NORTH ANNA POWER STATION, UNIT NO. 1

AMENDMENT TO FACILITY OPERATING LICENSE

Amendment No.67 License No. NPF-4

SAFETY EVALUATION BY THE OFFICE OF NUCLEAR REACTOR REGULATION

.Figure 5.1-1

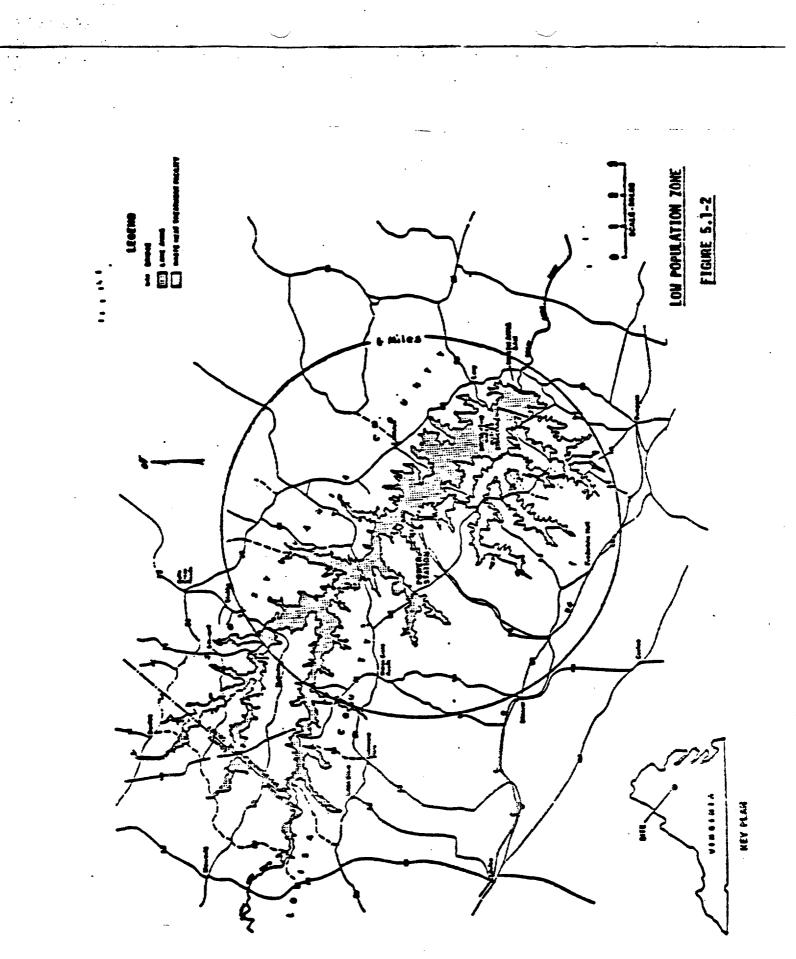
The NA-1&2 TS Figure 5.1-1 would be revised to include the location of the Meteorology (MET) tower. The location of the MET tower was inadvertently left out of the licensee's previous submittals.
